CALIFORNIA ENERGY COMMISSION

November 28, 2011

Subject: AHRI Comments on Residential Zoned Air-Conditioning

Figure 1. Overlay of AC Efficiency (watts cooling/watts energy consumed) in NAHB study

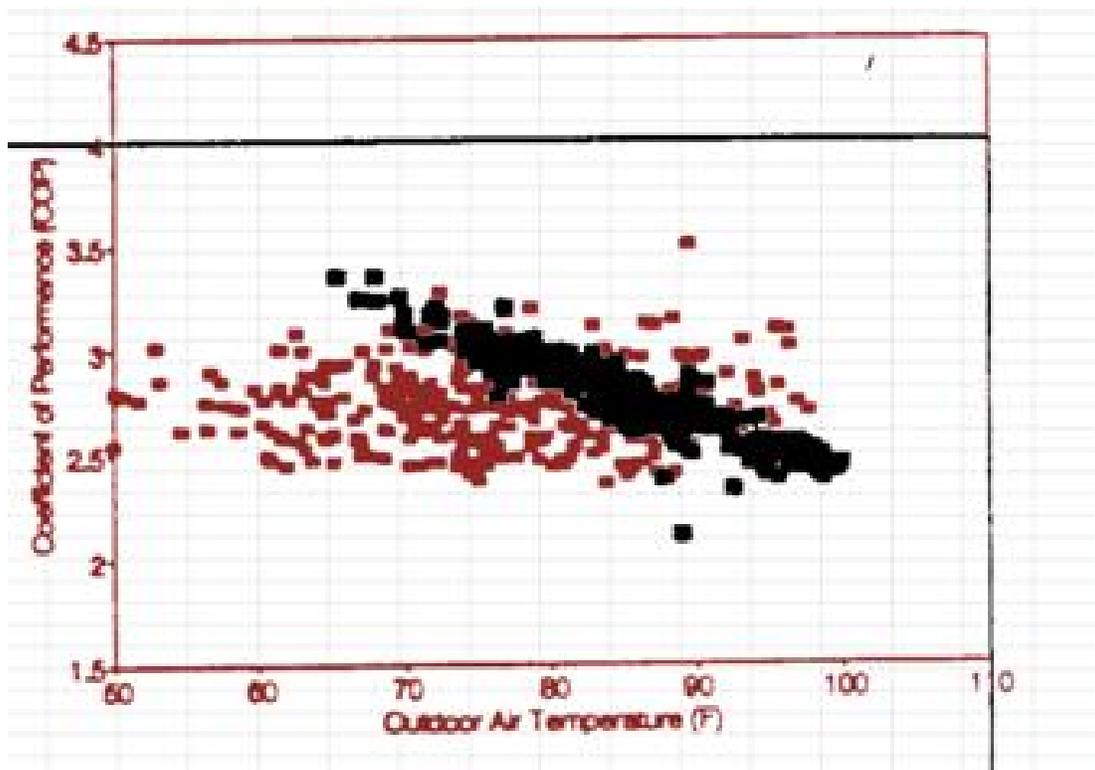
The cooling savings conclusions of the 1994 study are questionable due to two incongruities in the report. First, there is an unexplained, random distribution of air conditioner efficiency against outdoor temperature for the system operated as a whole house (single zone) system. But in the zoned operation, the study shows a typical air conditioner efficiency pattern against outdoor temperature. The reported efficiency of the unit as a whole house system was substantially lower than when operated as a zoned system in all but the highest temperatures. This is shown in Figure 1 (an overlay of the study’s Figures 3.2.2 and 3.2.3).

Second, the report states that “both systems experienced approximately the same percentage of hours in each temperature bin.” However the graphs in the report show vastly different “Typical Record Year” temperature bins — a statistic that should be identical between the two graphs.

Figure 2. Net Zoned System Efficiency with Bypass (Carrier Lab Data)

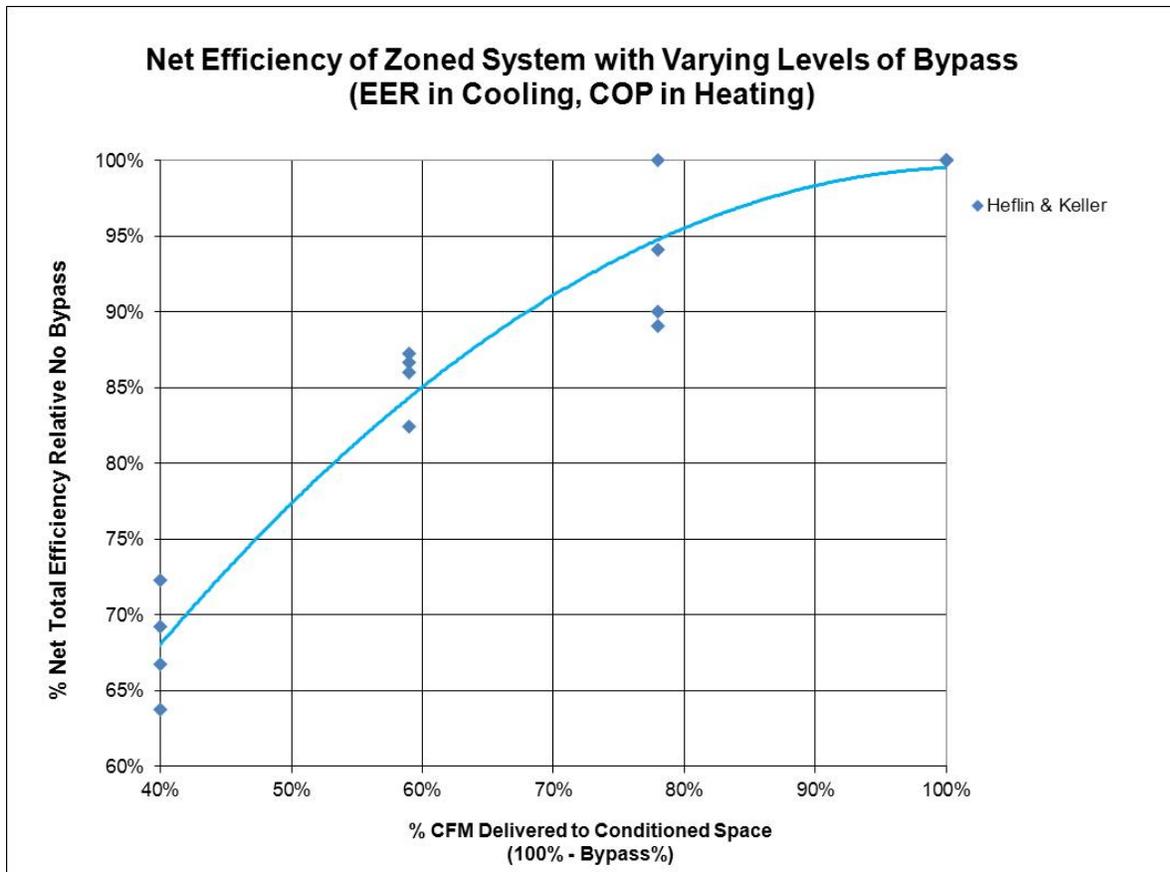
Figure 2 shows the loss of efficiency from recirculating air through a bypass. The left hand axis shows the percentage of efficiency relative to no bypass. The bottom axis displays the percentage airflow providing cooling or heating to the conditioned space. When 50% of the air is bypassed, the efficiency falls to 77% of its full value or a 23% loss in efficiency.

This paper did not present data on the reduction in sensible heat ratio as the amount of bypass increases. It is well known, however, that the recirculation bypass ducts reduce the sensible heat ratio and that the sensible energy efficiency ratio (EER) drops faster than the total EER, as plotted in Figure 2.

Figure 5. ACCA Manual Z Equation Approximates Field Unit 2

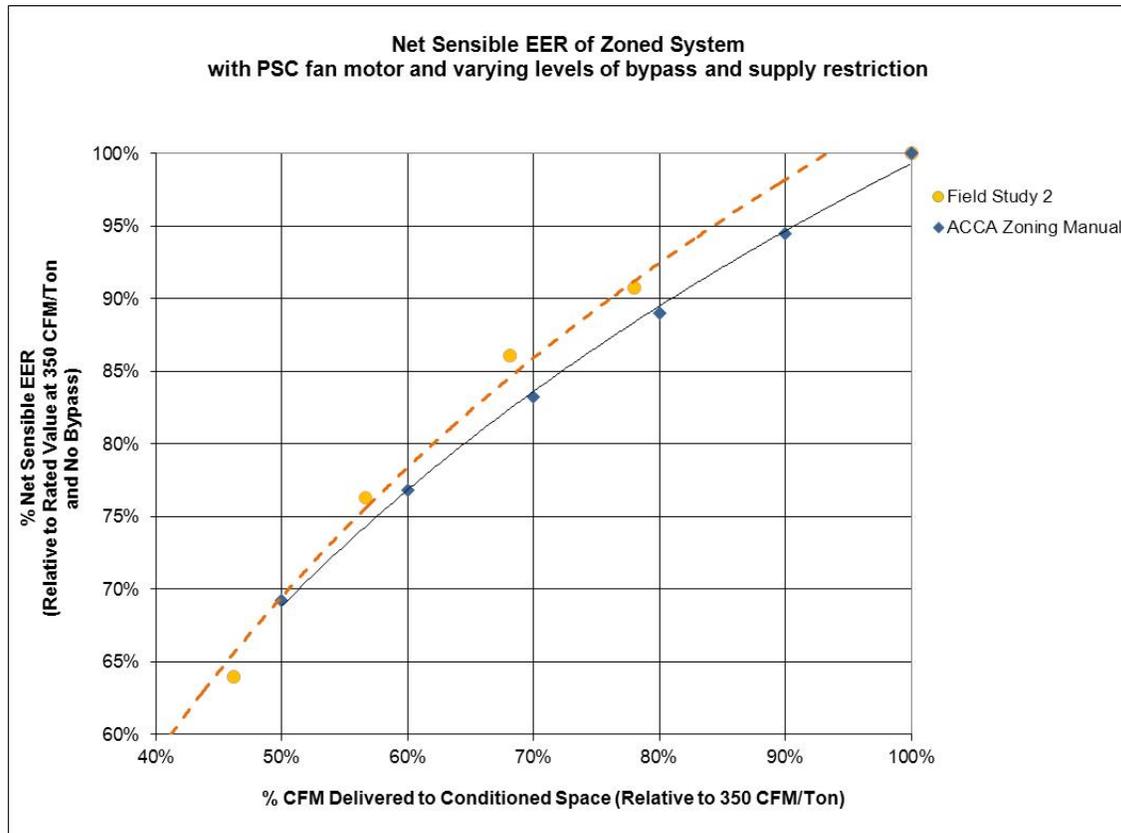
Air Conditioning Contractors of America is producing a manual titled “Zoned Comfort Systems for Residential Low-Rise Buildings” (Rutkowski 2011). The manual, which is currently in a public review draft, includes an equation (Figure 3) for estimating the supply dry bulb temperature based on the bypass factor and other operating conditions. The equation assumes a sensible heat ratio of 1.0, which is not achieved in the field. The result is an overestimate of the sensible cooling delivered to the house. While the equation produces an overly optimistic view of the sensible capacity of an air conditioner operating with a bypass, plotting the results of that equation shows that the reduction in efficiency from a bypass is approximately 31% for a 50% bypass. Figure 4 shows the numbers from that calculation for a 3 ton unit with 1050 CFM through the unit and varying levels of bypass. The results are plotted in Figure 5 and compared to the field data for unit #2.

Figure 6. Airflow Reduction with Multi-Zoned HVAC Systems

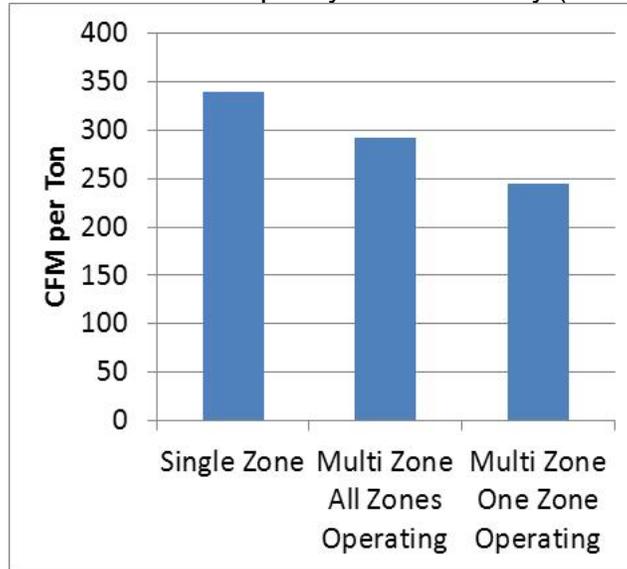
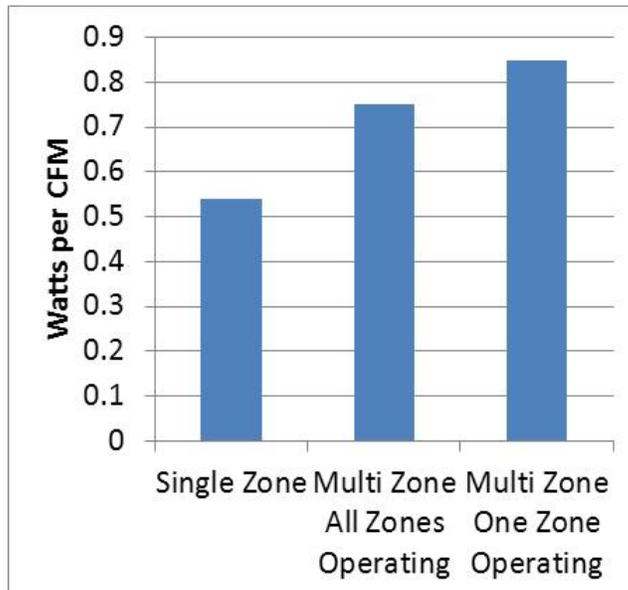
As displayed in Figure 6 and Figure 7, the ECO project found that the multi-zoned systems had significantly lower airflow and higher watt draws than single zoned systems. The differences were always significant at the .05 level. The result of the low airflow and high fan watts is reduced capacity and efficiency (both sensible and total).
